WOODBERRY FOREST ADDITIONS SUBDIVISION

APPLICATION NUMBER 4 DATE October 21, 2010

REQUEST Subdivision

DETAIL SITE PLAN

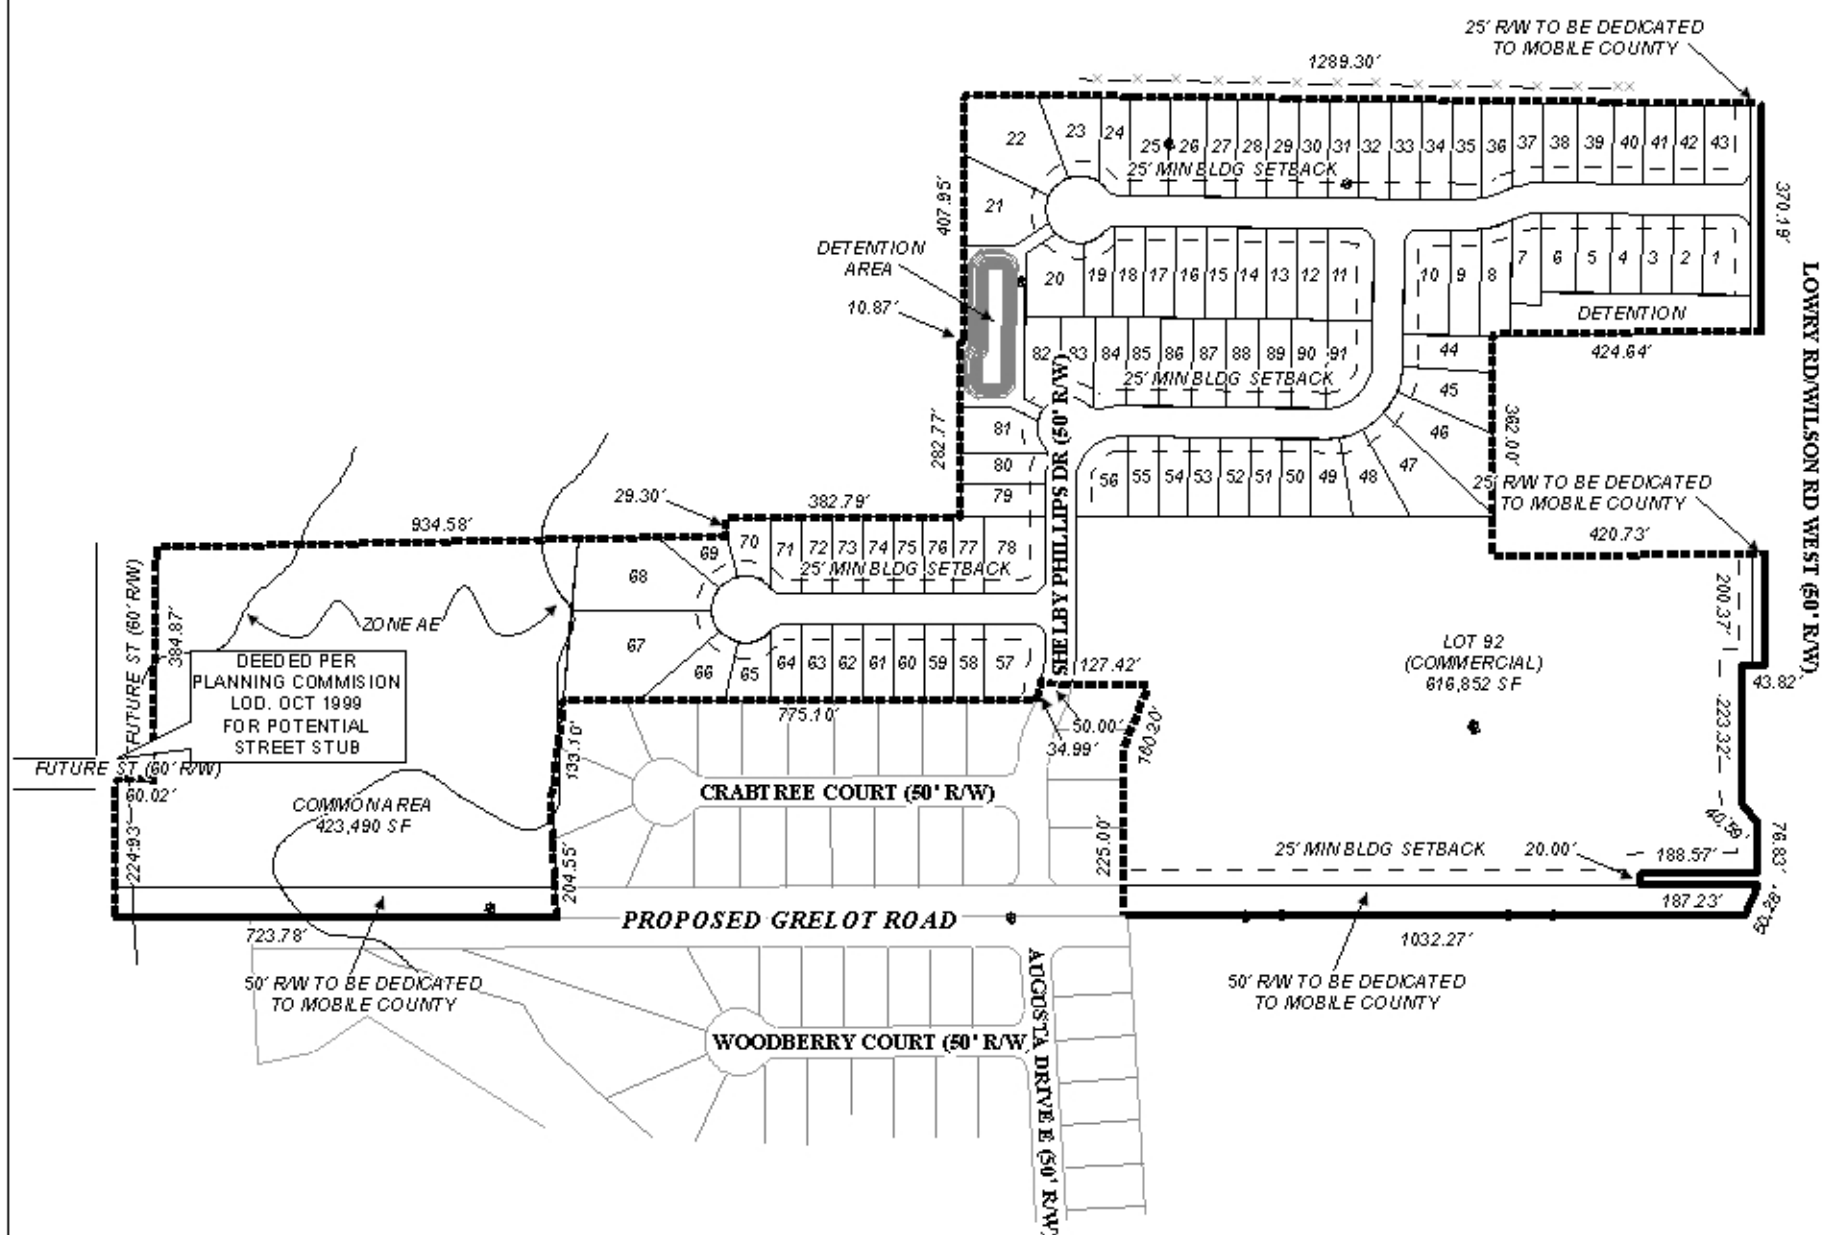
New street construction for this subdivision is proposed, including construction of two cul-de-sacs. Section V.B.14. of the Subdivision Regulations require a cul-de-sac turnaround to have a 120-foot diameter. The Preliminary Plat appears to depict a turnaround diameter of less than 120 feet, however no dimension is shown and scaling can sometimes be inaccurate. The applicant should label the size of the cul-de-sacs, and, if appropriate, modify them to meet the 120-foot width diameter requirement. The other streets appear to have a 50-foot width right-of-way, which meets the basic requirements of Section V.B.14., however, the right-of-way widths are not depicted, and the plat should be modified to depict them.

The 25-foot minimum building setback line is not depicted along all rights-of ways, and the plat should be revised to depict the 25-foot minimum building setback line along all rights-of-way, inclusive of any required dedications.

The revised plat indicates all required dedications for major streets. All dedication areas should be properly labeled as such. Also, documentation has been submitted indicating that the intersection of Air Terminal Drive/Wilson Road West and Grelot Road Extension is incorporated into the new traffic circle design in the area. As such, traditional curb radius requirements do not apply at this intersection, and a waiver of Section V.B.16. of the Subdivision Regulations regarding curb radii for this intersection only is appropriate.

There are some issues with the 25-foot minimum building setback line on the plat. The minimum building setback line is not depicted for Lot 92 along Shelby Phillips Drive. The minimum building setback line should be depicted along all public rights-of-way. The minimum building setback line appears to be depicted at less than 25 feet along the edges of the cul-de-sacs, and should be modified to reflect a 25-foot minimum building setback line.

Large areas of common area and detention area of indicated on the plat. A note should be placed on the Final Plat stating that maintenance of common areas and detention areas is the responsibility of the home owners association and not the City of Mobile or Mobile County.

Based on the preceding, and with a waiver of Section V.B.16. Curb Radii (radii shall not be less than 20-feet. Where an angle of intersection of less than 60-degrees is permitted, curb radii shall be increased as necessary to ensure safety) at the intersection of Air Terminal Drive/Wilson Road West only, this application is recommended for tentative approval subject to the following conditions:

- 1) retention of all notes on the Final Plat;*
- 2) depiction of the 25-foot minimum building setback line along Selby Phillips Drive on Lot 92 and along every public right-of-way;*
- 3) modification of the minimum building line along the cul-de-sacs to depict a 25-foot minimum building setback line;*
- 4) labeling of all right-of-way dedication areas as such; and*
- 5) placement of a note on the Final Plat stating that the maintenance of all common areas and detention areas are the responsibility of the homeowners association, and not the City of Mobile or Mobile County.*
